Ref: Application 2014/5873/P

OBJECTION TO PLANNING APPLICATION 2014/5873/P

We write in respect of Planning Application 2014/5873 (the "Application") in respect of the demolition and rebuilding and extension of 18-26 Hatton Wall (the "Proposed Development") as the resident leaseholders of Flat 3, Hatton Wall House, 28A Hatton Wall, which occupies the third and floor floors of the adjoining building to the west of the proposed development ("Flat 3"). Flat 3 is marked in yellow in the attached plans submitted with the Application in hard copy by post.

Flat 3, Hatton Wall House

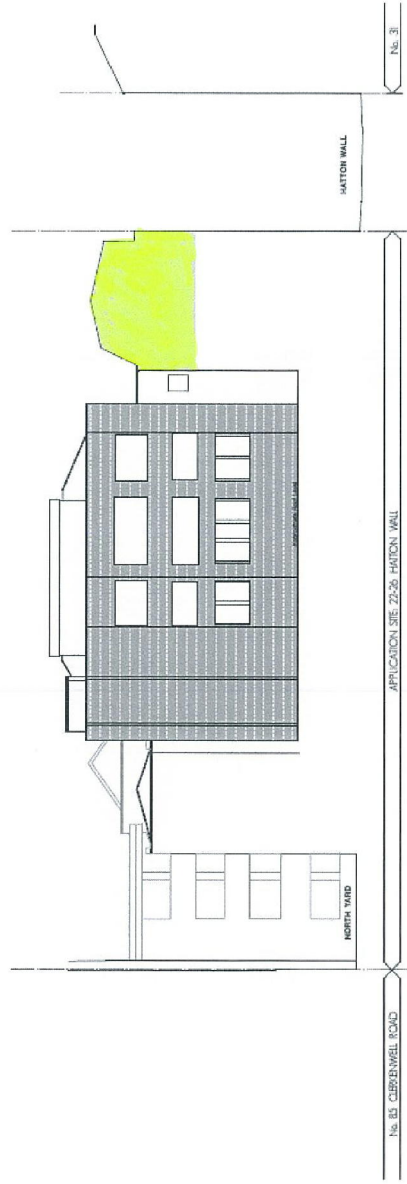
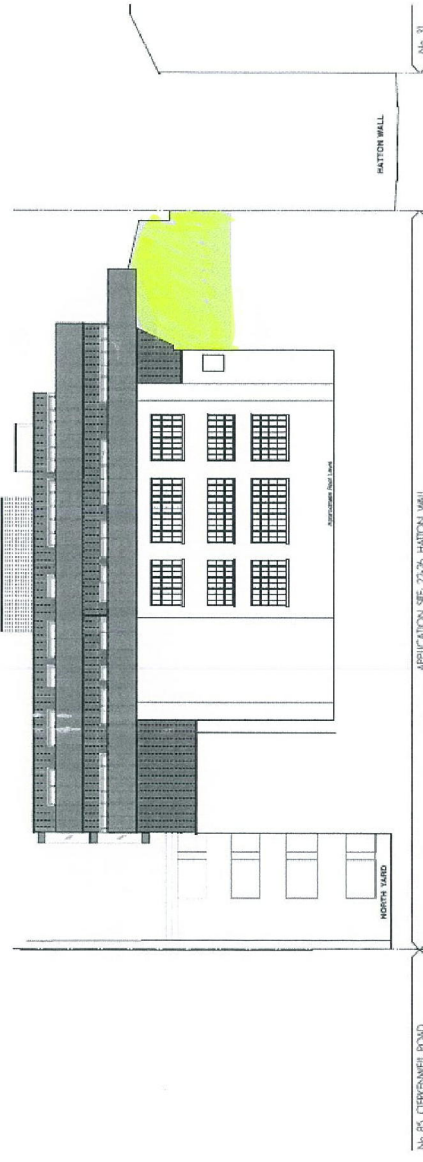
A significant contributor to the residential amenity of Flat 3 is the penthouse balcony that faces the courtyard and west elevation of the Proposed Development. As the existing building is only slightly higher than Hatton Wall House, an additional two floors in such close proximity to this balcony will have an oppressive and claustrophobic effect and causing significant detriment to amenity of this feature.

The Proposed Development entails the extension of the site by two further stories—two stories higher than any other building on Hatton Wall—with full balconies wrapping around both stories on the elevation facing Flat 3.

Whilst the balcony of Flat 3 is perpendicular to the side of the Proposed Development, the distance between the two buildings is significantly less than 18m (estimated at less than 6 metres). Note that this loss of privacy would not only be also suffered by Flat 3, but also by the units on Leather Lane with windows directly facing this elevation of the Proposed Development.

While recognising that the current plans for the Proposed Development attempt to mitigate this loss of privacy by the inclusion of perforated screens, the approximately waist-high height of the proposed screening only serves to partially obstruct views into the newly proposed residential units, and leaves Flat 3's balcony and the living area behind visible through the large sliding windows completely exposed.

In combination with the extreme lateral proximity and the extension in building height by two stories towering over the existing roof line as experienced from properties facing the courtyard, this is an unacceptable loss of privacy and amenity to Flat 3.

- Submission a satisfactory daylight and sunlight report that satisfies the Camden Local Area Requirement for such by assessment of the flats in Hatton Wall House
- Revision of the plans for the Proposed Development to ensure preservation of Flat 3's residential amenity and privacy. Having studied the current plans for the Proposed Development, we struggle to imagine how any adjustments to the proposed two story extension of the building, apart the extension's complete omission, might mitigate these issues in an acceptable way.
